Re: "DART+ West Electrified Railway Order 2022"

Please find attached my observation in respect of the above railway order pertaining the partial acquisition under CPO of Ashtown Stables for the purposes of a proposed access road at Ashtown due to the proposed level crossing closure at Ashtown.

Figure 1 Section B-B stable lands on left, Section C-C stable lands on right.

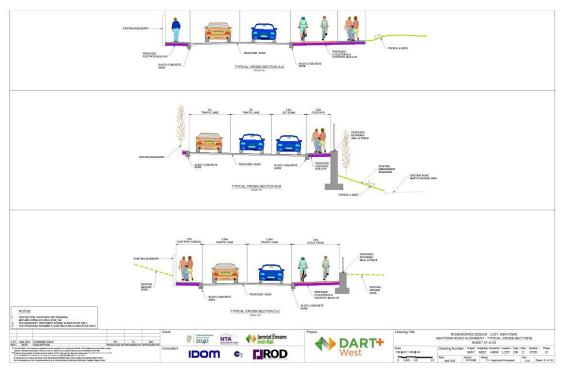
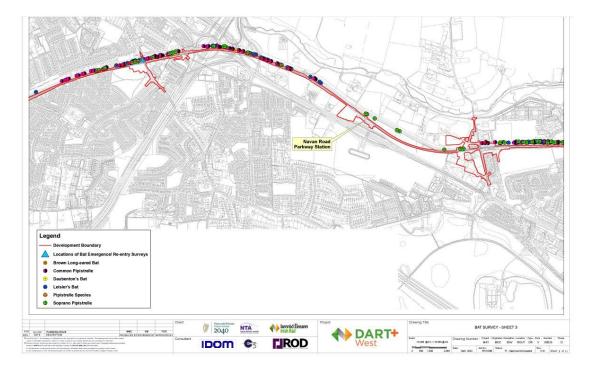
I welcome that item 4.1.1.1 Request for Avoidance of Relocation / Destruction of Ashtown Stables has been substantively addressed in the retention of Ashtown Stables in the current Railway order. However item 4.1.1.8 is of note here due to the high value biodiversity value of the site. In the submitted railway order the proposed works at Ashtown require a new access road and underpass to the west of the stables. This requires a partial CPO and temporary works CPO along the boundary condition of Ashtown Stables. The proposed development requires substantive tree and hedgerow removal from the southern portion of the lands of Ashtown Stables. No reference in the EIAR could be found in respect of mitigation vis a vis protected species on the lands of Ashtown Stables. No arboricultural survey appears in the publicly available documents online pertaining to the vegetation cover at the lands at Ashtown Stables. No detailed proposed planting plan has been presented in the publicly accessible documentation for Ashtown Stables. Section B-B for Ashtown on drawing 0105 appears to indicate the existing boundary is retained to the north eastern part of the lands. Section C-C requires a new boundary condition.

These drawings are schematic and lack detail. As no detail planting plan is proposed it is of concern as to the type of proposed species and specification of the any reinstatement planting. Some species such as oak for example are toxic to equines and are specified on the proposed planting schedules drawing, 15141.

The extent of land under CPO of the stable lands is not dimensioned where heavy intervention is proposed along the boundary condition. There is a lack of clarity on mitigation *if any* on the biodiverse integrity and green infrastructure of Ashtown Stables in the proposed Railway order for Dart West.

Figure 4 Top: Railway order Landscape impact drawing, Below: Railway order proposed mitigation. Note no trees noted for removal on southern part of Ashtown Stable lands under CPO in landscape impact drawing. These are noted for removal on the landscape mitigation drawing.

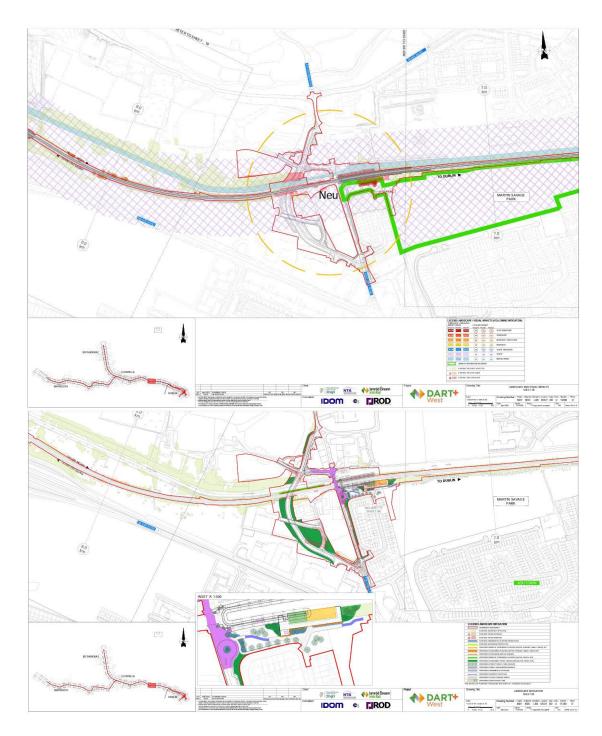
Here trees and hedgerows for removal are not documented in the landscape impact drawing yet is on the proposed mitigation plan. A new boundary condition is required to the south and south west. Yet the specific trees and hedging are not specified. For example Quercus robur (English Oak) and Quercus palustris (pin oak) are described as the type of trees that may be used as street trees on drawing 15108. Both oaks are toxic to equines and demonstrates that no consideration was given to the planting scheme 15108 which pertains to Ashtown Stables. Quercus palustris is a non-native tree is inappropriate as a reinstatement of the native trees and hedgerow that are extant on the lands of Ashtown Stables. To the south west the existing vegetation, trees and hedgerow are noted as retained yet a new boundary condition is proposed on section C-C aforementioned. Any trees specified are at a maximum girth size of 10-12cm girth or maximum height of 2.5m tall or as whips at 900mm tall. 'Street' trees are a maximum size of 16/20cm girth (no height specified). 10-12cm girth is not a 'semi-mature' tree and whips at 900mm tall will be significantly poorer in visual amenity for the foreseeable future to that which the public currently enjoy. The meagre planting schedule presented cannot replace the current setting in any meaningful way.
